**NABI 60BRT: Cooling System Updates (4B)**

**Property name and top bus number:** NABI 60BRT buses equipped with EGR cooler

**Issue:** Air in the cooling system.

Work instruction number L3/FSV-126  
L4/QUA-003

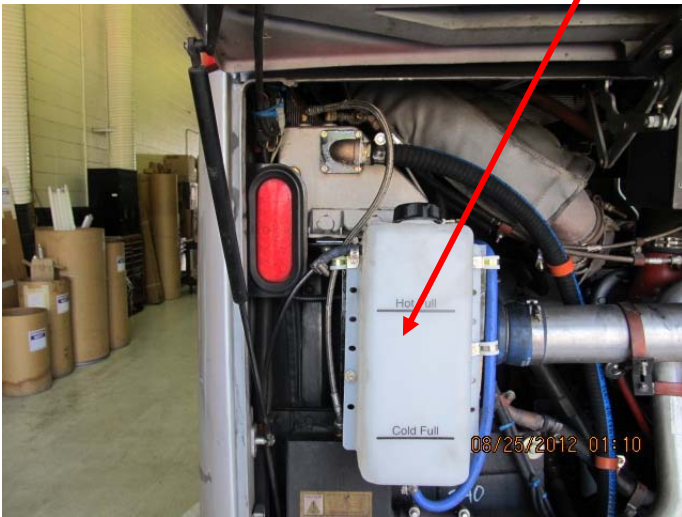
4. Replace existing surge tank fill cap with new adapter plate assembly, which includes 90 elbow and 1" hose barb. Seal treads with thread sealant.

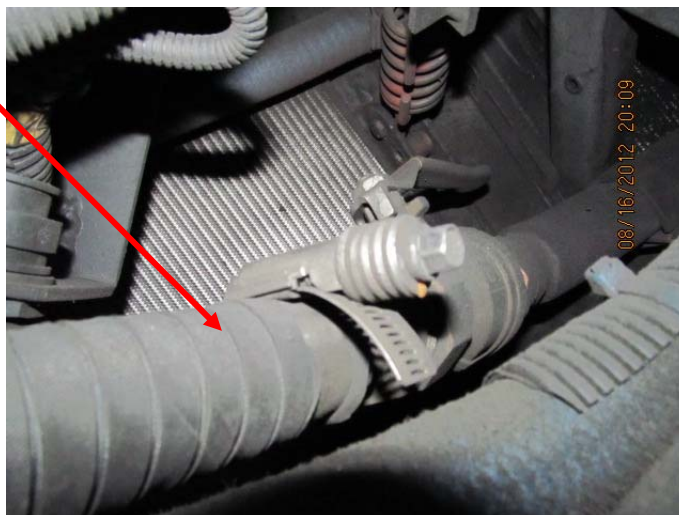
- Route 10' of EZ Form hose from adapter plate on surge tank and secure it with P-clamps as pictures show below.
